Text Details 8 Hazelbury Close

Applicant: Mr Dean Sewell Mrs Edyta Cholewinski			
Project: 8 Hazelbury Close SW19 3JL			
QUBED UK LTD Architecture 106 Pelham Road SW19 1PA 02082 863 927 www.qubedarchitecture.co.uk			
Stage: PLANNING			
Drawing: Proposed Plans, Elevations and Section			
Number HC 02	Revision F	Scale 1:100@A1 1:200@A3	Date 11 08 2014

SIDE ELEVATION

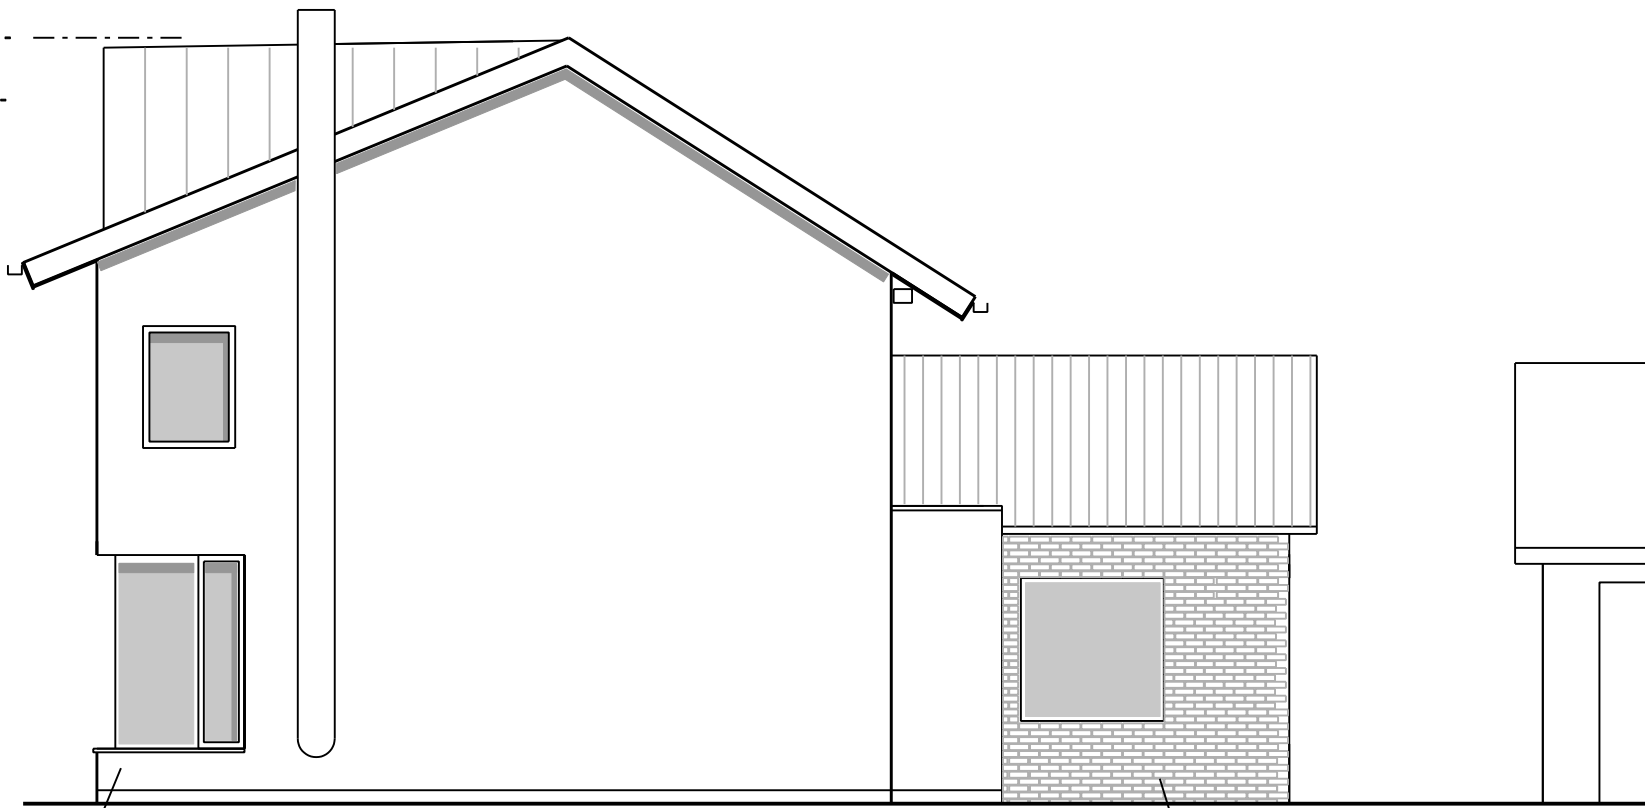
Ridge height - as approved
Dormer size - as approved

Simplified elevations with continuous highly insulated render system, including wrapping all windows frames to reduce losses. Removal of timber cladding from ground floor.
Dormer material changed to zinc, colour to match roof.
(Note, dormer set-back 1.2m, barely visible from the street)

Bricks used in single storey element in place of timber cladding (as approved).

Removal of clerestory windows and change to standard pitched roof form resulting in improved overall building performance for the single storey element.

FRONT ELEVATION

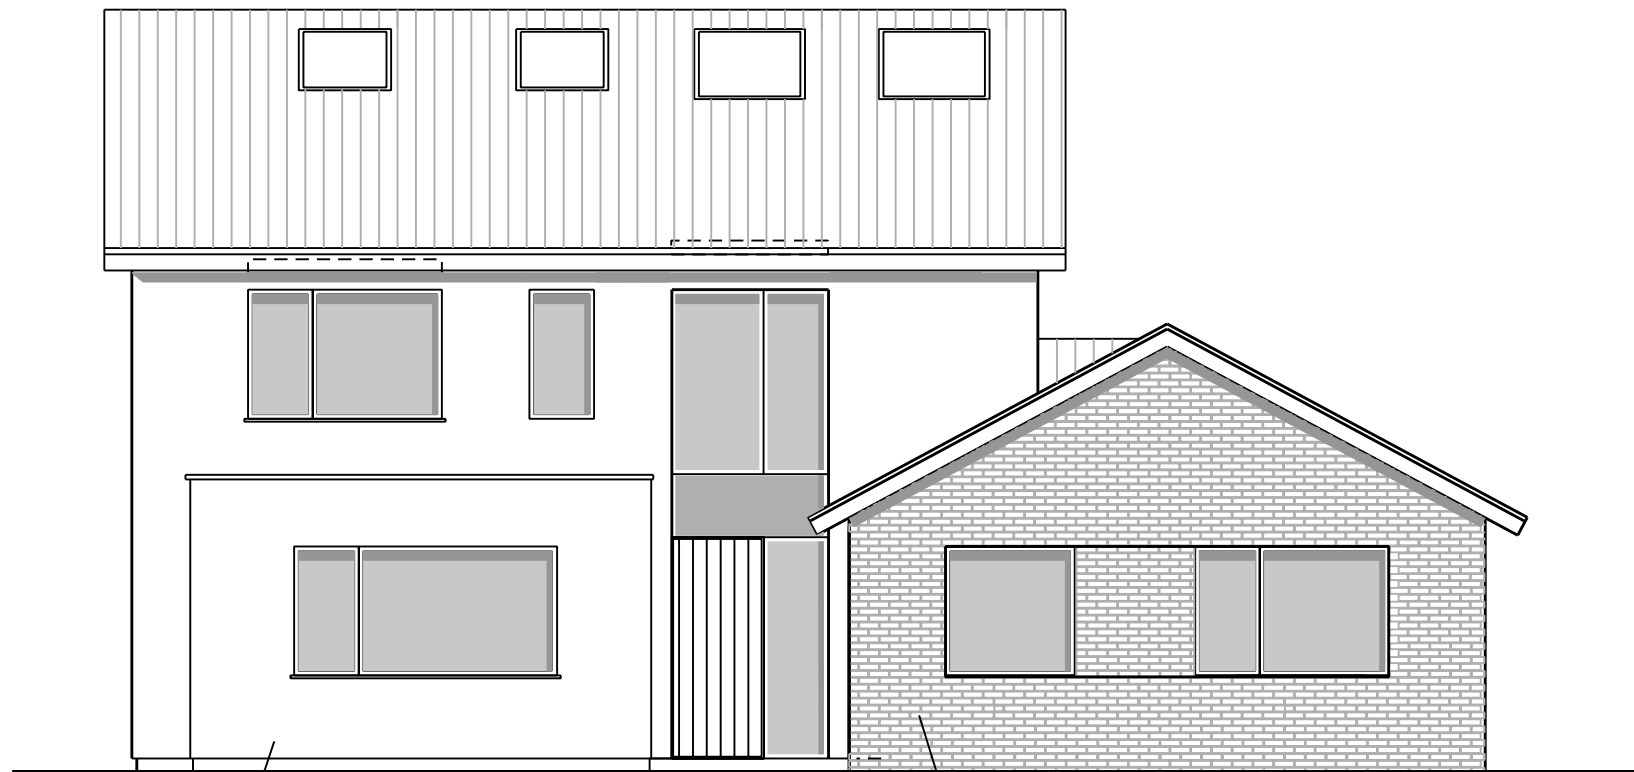
South facing window amended to improve solar gain.

Window amended to increase solar gain and reduce thermal losses.

Bricks (as above).

REAR ELEVATION

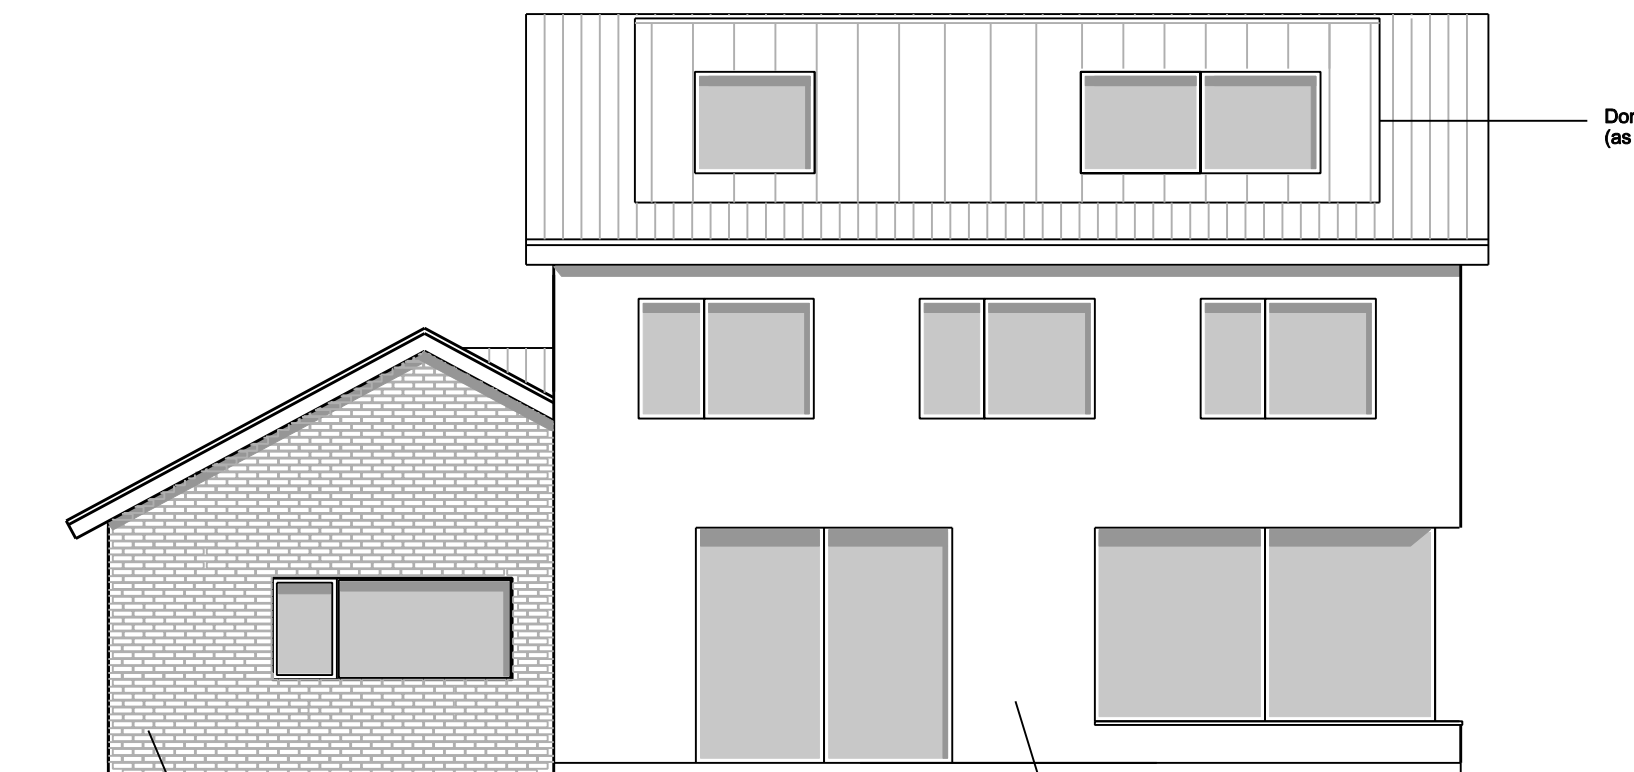
Simplified roof form (as above).

Dormer material (as above).

Bricks as above.

Simplified roof form (as above).

Simplified elevations (as above).
